RE: Adjustable Performance Counterweight (APC), Part Number 1001210345,
1001210345S, or 1001210346S

Subject: Replacement of Mounting Hardware

PROCEDURE: Adjustable Performance Counterweight (APC) Mounting Hardware Replacement

Figure #1

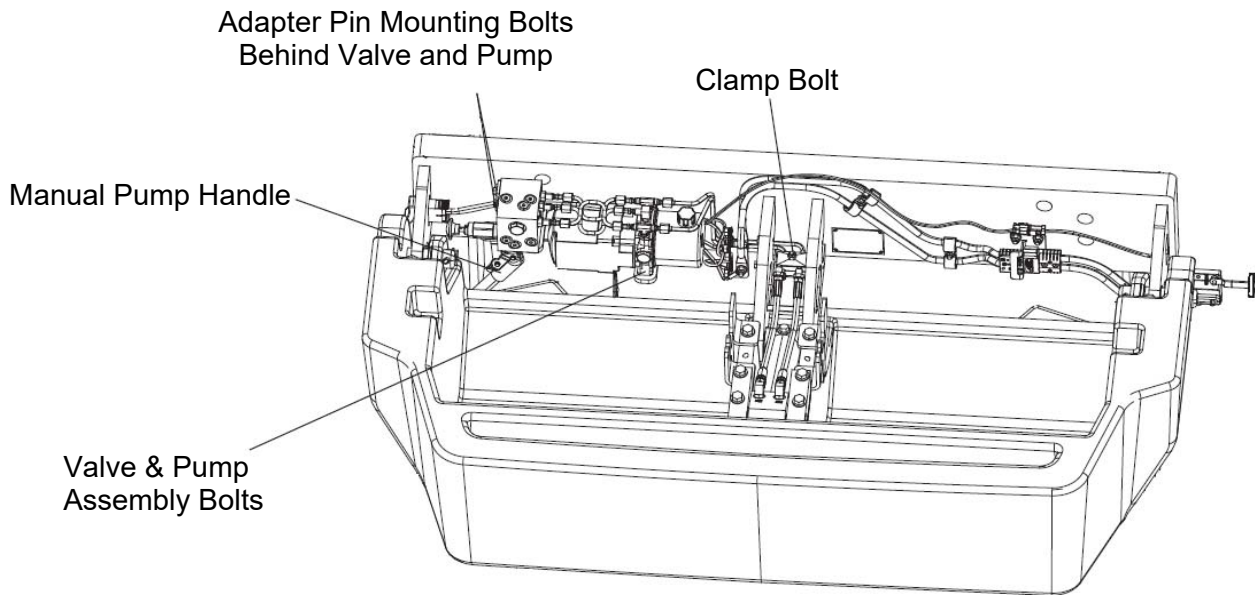
3. Place a "Do No Operate" Tag on the steering wheel and remove the ignition key.
4. Lower the counterweight to the horizontal position.
5. Properly support the counterweight.
6. Remove any weights as necessary to access the mounting hardware.
7. On the passenger side, remove the four bolts holding the valve and pump assembly as shown in Figure #1.
8. Loosen the steel line clamp to allow the movement of the valve and pump.

9. Move the valve and pump away from mounting plate to allow access to the adapter pin mounting hardware. Support pump and valve to prevent bending hydraulic tubing.

Figure #2

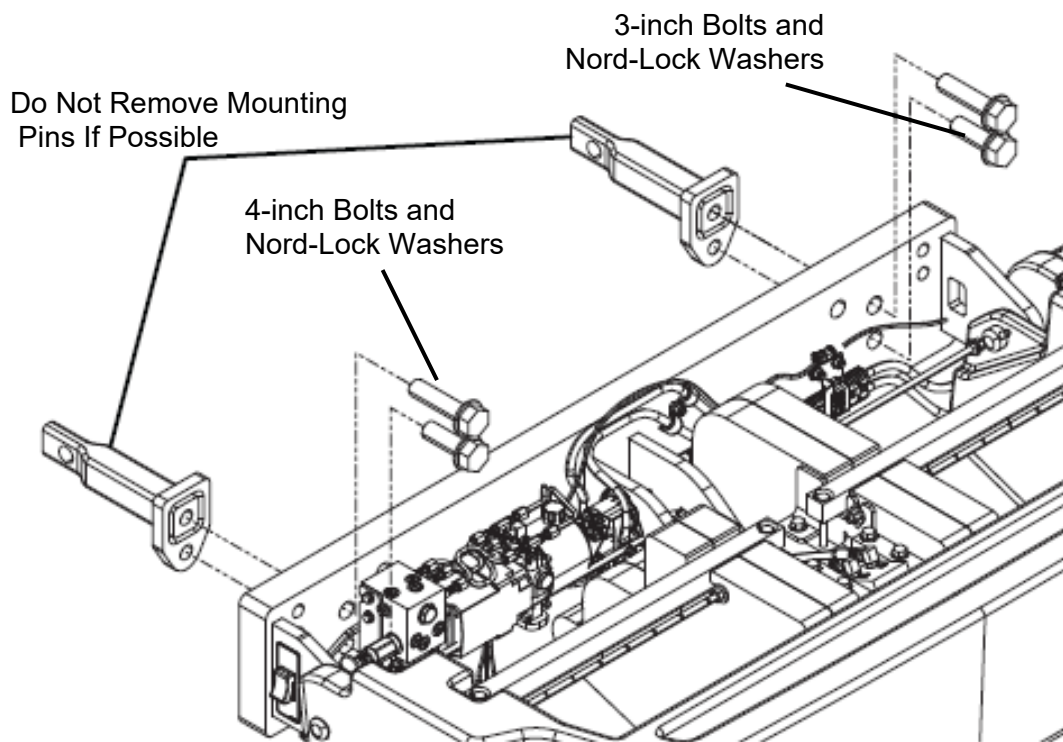
- f. When installing mounting pins to the truck chassis, utilize new shoulder bolts (#1001210455) and nyloc nuts (# 7660222601) supplied with kit and torque to 230 ft-lbs.
11. Using the Nord-Lock washers (# 1001253788) and bolts supplied with the kit, apply red Loctite 243 to the entire length of threads of the 1-inch X 3-inch (#0682624) and 1-inch X 4-inch (#0682632) bolts.

IMPORTANT: Insure the 4-inch-long bolt is used on top and the 3-inch-bolt is used on the bottom, Reference Figure #2.

12. Torque the mounting bolts to 760 – 770 ft-lbs.
